Docket No. 50-440

SUBJECT: CORRECTION TO AMENDMENT NO. 20 TO FACILITY OPERATING LICENSE
NO. NPF-58

SAFETY EVALUATION BY THE OFFICE OF NUCLEAR REACTOR REGULATION
RELATED TO AMENDMENT NO. 20 TO FACILITY OPERATING LICENSE NO. NPF-58

PERRY NUCLEAR POWER PLANT, UNIT NO. 1

FIGURE 3.2.1-1

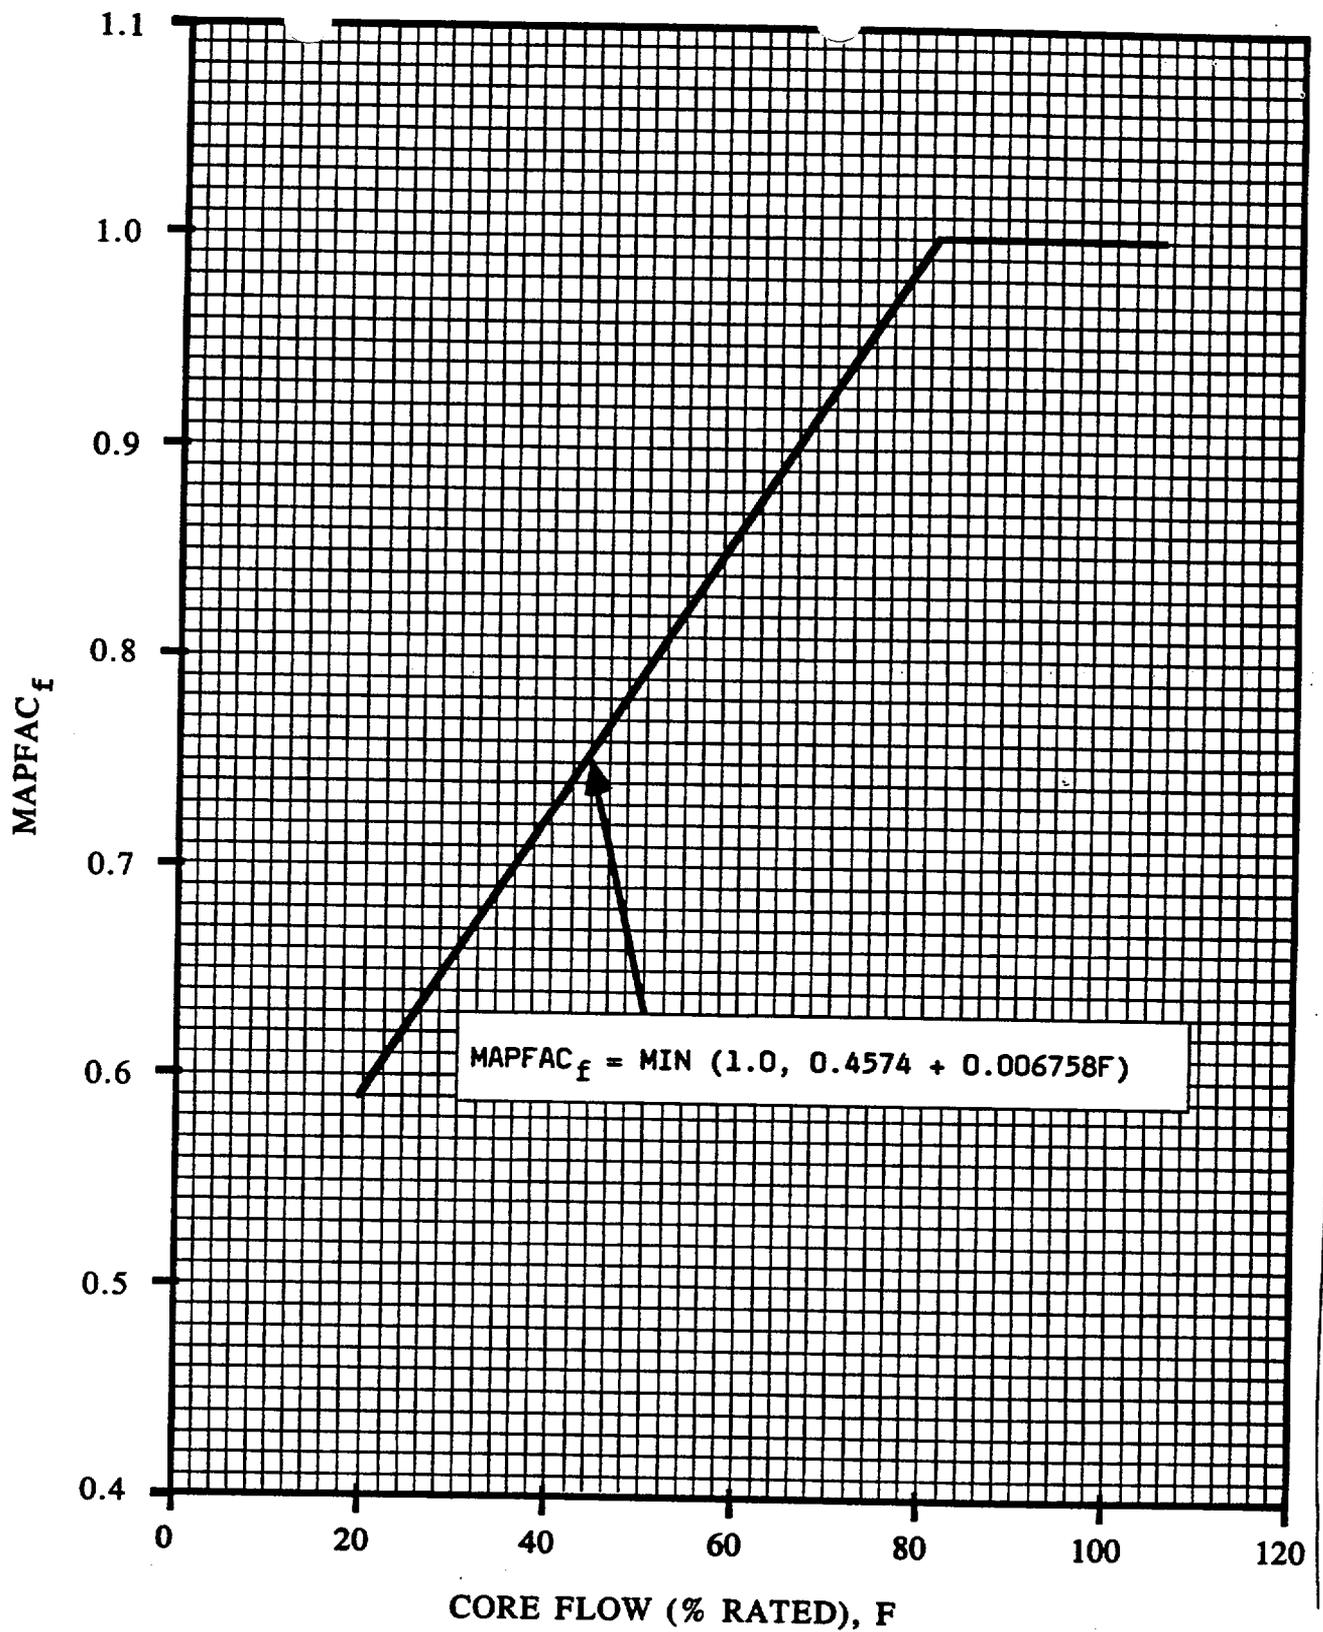
Modification of the $MAPLHGR$ versus average exposure for each fuel type in Cycle 2. Figures 3.2.1-1, 3.2.1-2, 3.2.1-4 and 3.2.1-5 were renumbered, Figure 3.2.1-3 was deleted. Figures 3.2.1-5 and 3.2.1-6 were added. These changes have been discussed above and are acceptable. Also, as discussed above, the new Figure 3.2.1-1 was modified to extend the curve to the 20% of rated core flow line. This change is acceptable.
